SUBJECT: THREE MILE ISLAND NUCLEAR STATION, UNIT 1 - STAFF ASSESSMENT OF INFORMATION PROVIDED PURSUANT TO TITLE 10 OF THE *CODE OF FEDERAL REGULATIONS* PART 50, SECTION 50.54(f), SEISMIC HAZARD REEVALUATIONS FOR RECOMMENDATION 2.1 OF THE NEAR-TERM TASK FORCE REVIEW OF INSIGHTS FROM THE FUKUSHIMA DAI-ICHI ACCIDENT (TAC NO. MF3905)

STAFF ASSESSMENT BY THE OFFICE OF NUCLEAR REACTOR REGULATION

RELATED TO SEISMIC HAZARD AND SCREENING REPORT

THREE MILE ISLAND NUCLEAR STATION, UNIT 1

Figure 3.3- 1 Plot of Staff's and Licensee's Base Case Shear-Wave Velocity Profiles for the TMI Site

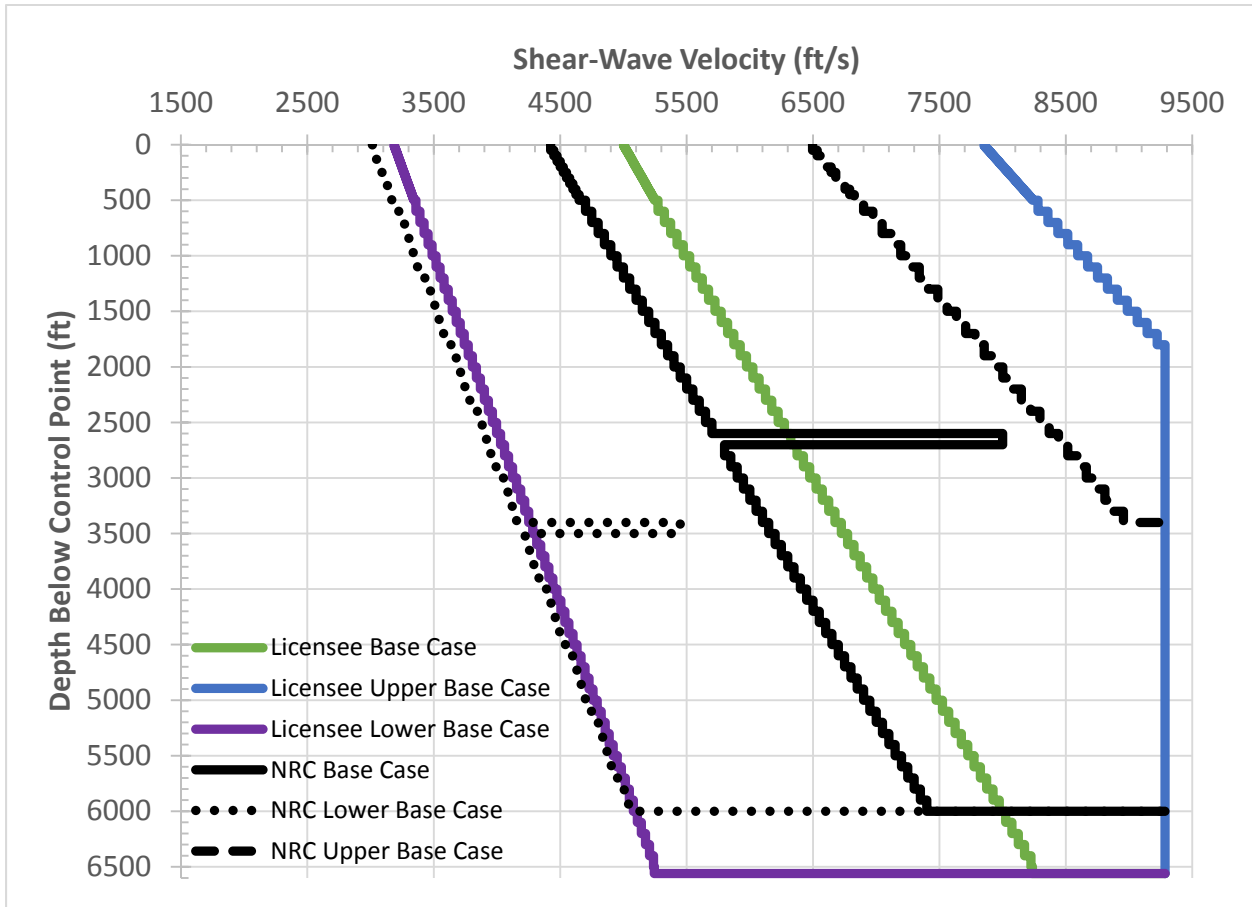
To characterize the subsurface geology, the licensee developed three site base case profiles. The middle, or best estimate, profile was developed using a shallow velocity of 5,000 fps (1,524 m/s) reflecting a Poisson ratio of 0.35 and assumed a shear wave velocity gradient of 0.5 m/s/m. Upper and lower base case profiles were developed using a scale factor of 1.57 to reflect a natural log standard deviation of 0.35. Figure 3.3-1 of this assessment shows the licensee's three shear-wave velocity base case profiles.

Following guidance provided in the SPID for sites with less subsurface information, the staff independently determined best-estimate and upper and lower base case shear-wave velocity profiles. The NRC staff based its best-estimate velocity profile on information in the TMI UFSAR and guidance provided in the SPID. The staff modeled the velocity at the top of rock with a shear-wave velocity of 4,425 fps [1,349 m/s]. This velocity corresponds to a Poisson's ratio of 0.37, given an average compressional wave velocity of 9,700 fps [2,957 m/s], which is based on seismic refraction profiles in the TMI UFSAR. Consistent with guidance in the SPID, the NRC staff used a velocity gradient of 0.5 fps/ft to model the increase in shear-wave velocity with depth. Based on geologic maps of the region surrounding the TMI site (Bert, et al., 1980; Miles, et al., 2001), the NRC staff included a layer of diabase in the site profiles. Because the depth of this layer beneath the TMI site is uncertain, the NRC staff included it at a different depth in each base case. The NRC staff used a natural log standard deviation of 0.3 to calculate upper and lower base case velocity profiles. Figure 3.3-1 of this assessment shows a comparison of the three profiles developed by the licensee with those developed by the staff. Overall, the profiles developed by the NRC staff are weighted towards slightly lower velocities than those assumed by the licensee. The NRC staff randomized the depth to reference rock by  $\pm 10$  percent to allow for additional uncertainty.

**Figure 3.3- 2 Plot Comparing the Staff's and the License's Median Amplification Functions and Uncertainties for Two Input Loading Levels for the TMI Site**

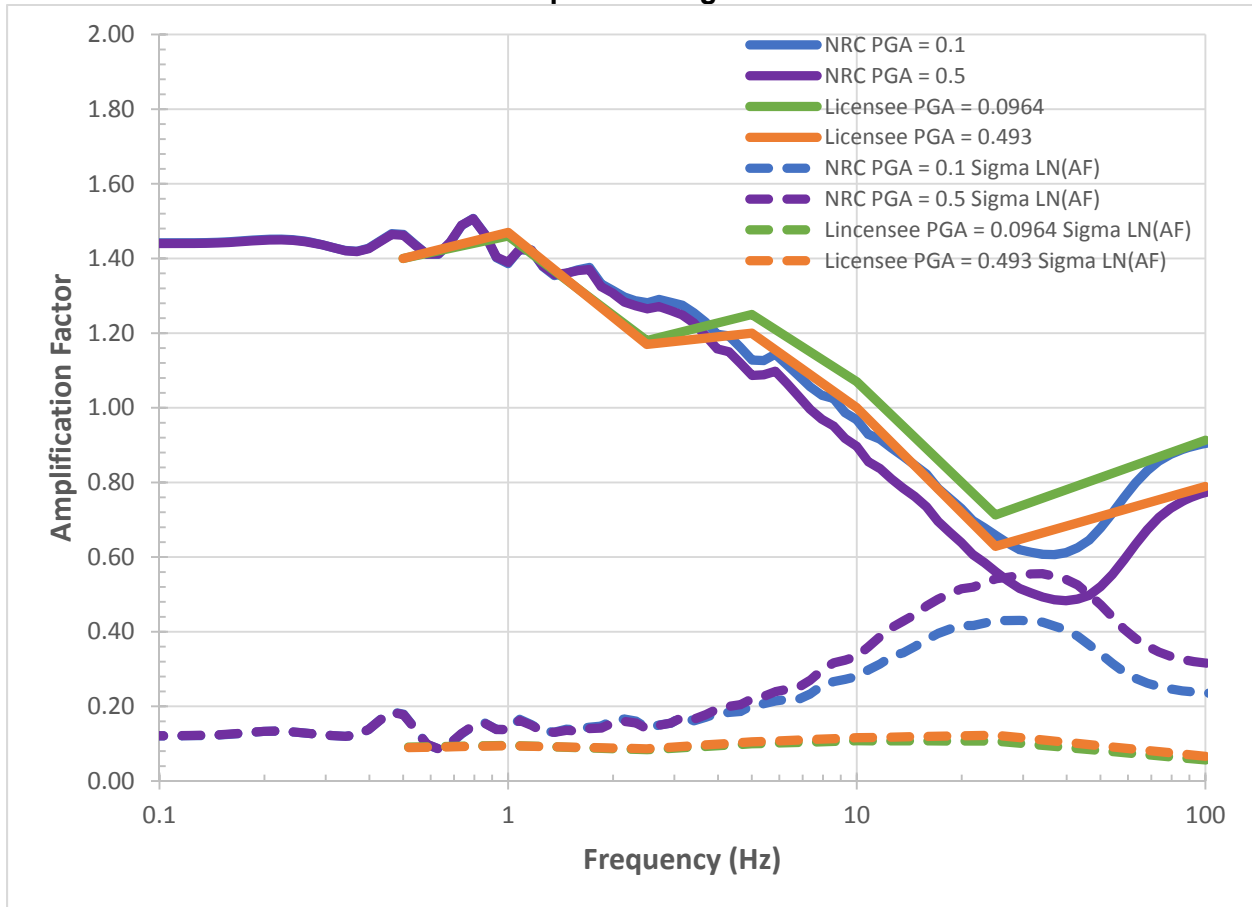
Figure 3.3-2 of this assessment shows a comparison of the NRC staff's and the licensee's median site amplification functions and uncertainties ( $\pm 1$  standard deviation) for 2 of the 11 input loading levels. The amplification functions are highest at frequencies of less than 1 Hz and decrease with increasing frequency. Amplification functions calculated by the NRC staff and the licensee are similar, however uncertainties are higher for the staff's profiles. This is due to the greater epistemic uncertainty in the staff's kappa values and damping parameters.

Figure 3.3-3 Plot Comparing the Staff's and the Licensee's Mean Control Point Hazard Curves at a Variety of Frequencies for the TMI Site

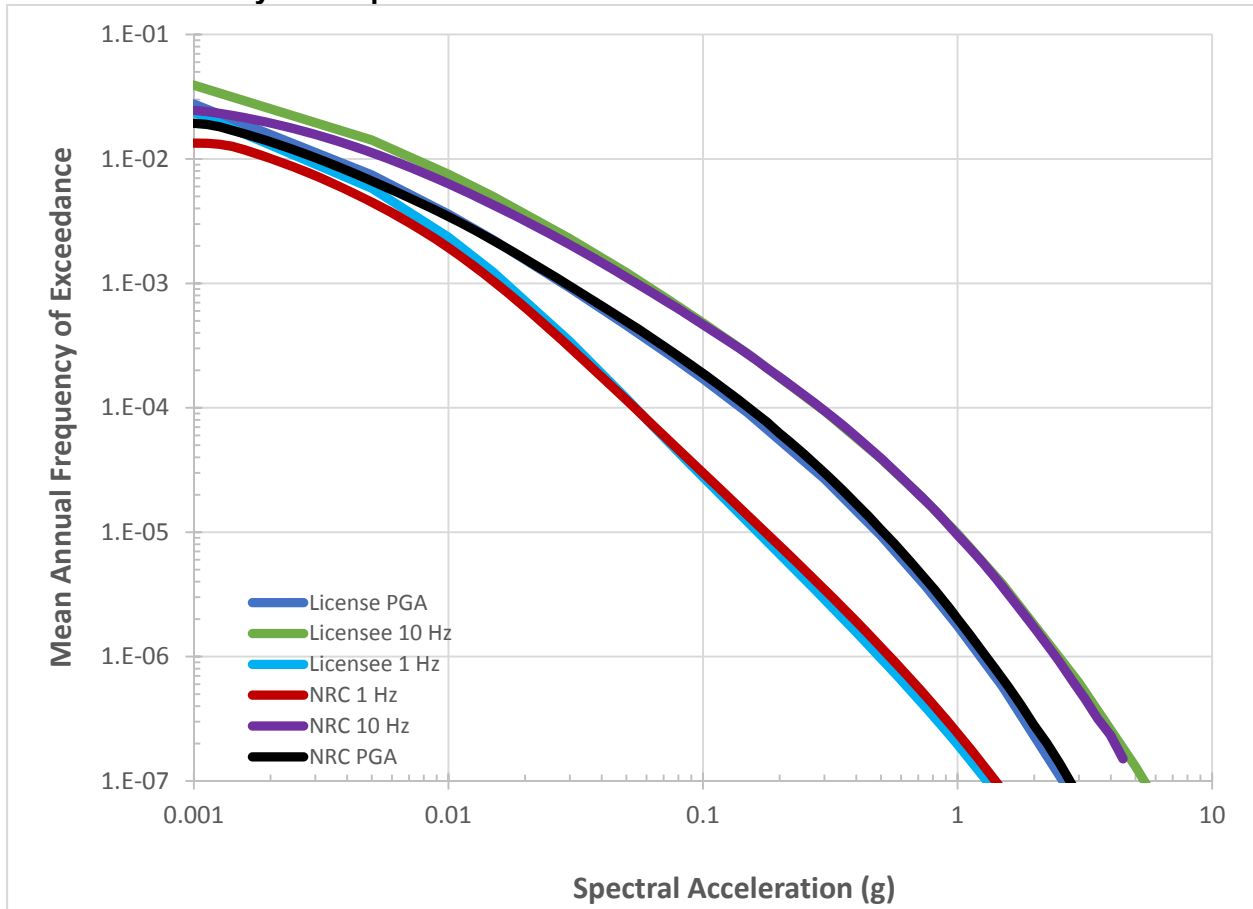
The licensee's approach to modeling the subsurface rock properties and their uncertainty results in similar site amplification factors to those produced by the NRC staff. As shown in Figure 3.3-3 of this assessment, minor differences in site amplification and uncertainty has a very minor impact on the control point seismic hazard curves and the resulting GMRS, discussed below. Appendix B of the SPID provides guidance for performing site response

Figure 3.4-1 Comparison of the Staff's GMRS with Licensee's GMRS and the SSE for the TMI Site

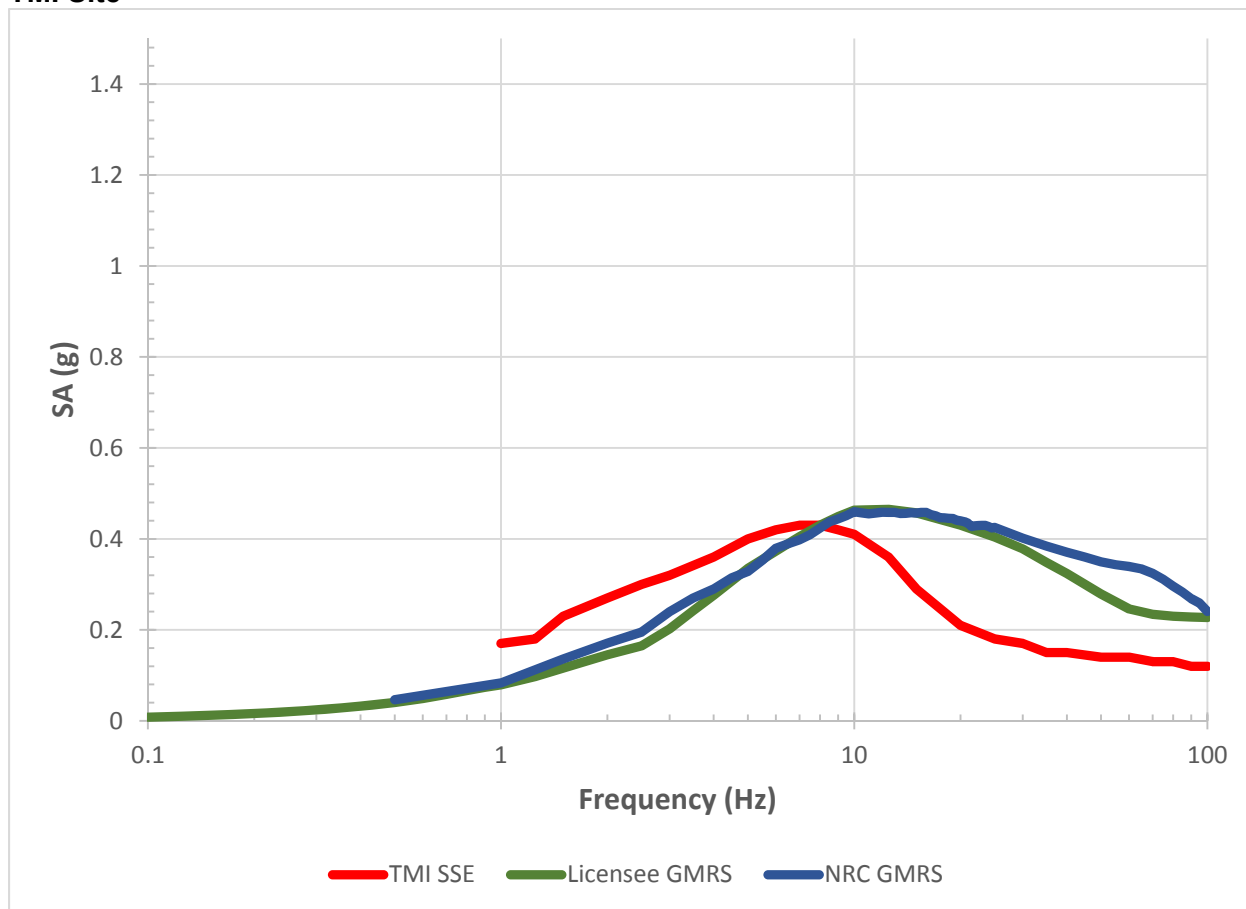
The NRC staff independently calculated the  $10^{-4}$  and  $10^{-5}$  UHRS using the results of its confirmatory PSHA and site response analyses, as described in Sections 3.2 and 3.3 of this assessment, respectively. Figure 3.4-1 of this assessment shows a comparison of the GMRS determined by the licensee to that determined by the NRC staff.

As shown in Figure 3.4-1, the licensee's and NRC staff's GMRS shape are very similar. The licensee's GMRS is somewhat lower than the NRC staff's confirmatory analysis at varying frequencies, particularly above 25 Hz. As described above in Section 3.3, the NRC staff concludes that these minor differences over this frequency range are primarily due to the differences in the site response analyses performed by the licensee and NRC staff.

The NRC staff confirms that the licensee used the present-day guidance and methodology outlined in RG 1.208 and the SPID to calculate the horizontal GMRS, as requested in the 50.54(f) letter. The NRC staff performed both a PSHA and site response confirmatory analysis and achieved results consistent with the licensee's horizontal GMRS. As such, the NRC staff concludes that the GMRS determined by the licensee adequately characterizes the reevaluated hazard for the TMI site. Therefore, this GMRS is suitable for use in subsequent evaluations and confirmations, as needed, for the response to the 50.54(f) letter.
